TITLE NEW STATIC DISCHARGE SPRING			PIB NO DK3024A		
PRODUCT LINE: TAPE DISK FORMATTER	<input type="checkbox"/> TAPE <input checked="" type="checkbox"/> DISK <input type="checkbox"/> FORMATTER	EQUIPMENT CHANGE NO. Belt Guard Assy 102748	MODEL SERIES AFFECTED D3000	EFFECTIVE DATE April 5, 1976	
CLASS OF BULLETIN: <input type="checkbox"/> IMPROVEMENT <input type="checkbox"/> RETROFIT ON FAILURE <input type="checkbox"/> RETROFIT RECOMMENDED <input checked="" type="checkbox"/> SERVICE INFORMATION ONLY		ORDER PART KIT NO. 103764-01	EFFECTIVITY This PIB replaces PIB DK3024 in its entirety. PIB DK3024 should be discarded and replaced by PIB DK3024A.

NEW STATIC DISCHARGE SPRING

PIB NO.
DK3024A

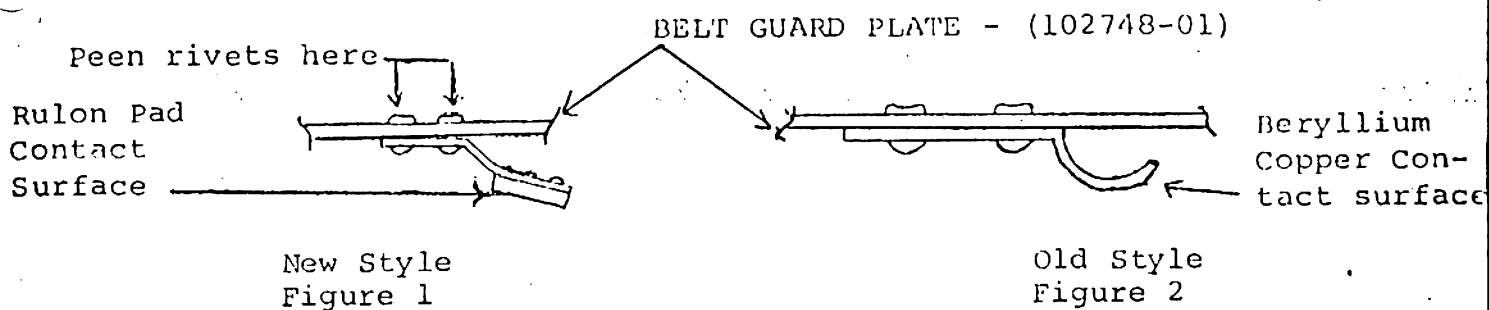
A new static discharge spring is now being used on the D3000 belt guard assembly (PERTEC P/N 102748-01) which provides for increased wear life of the spring. The new spring (Fig. 1) uses a rulon pad on its contact surface which makes it easy to distinguish from the old style single piece beryllium copper spring (Fig. 2). The new spring, unlike the old, does not require conductive lubricant on its contact surface.
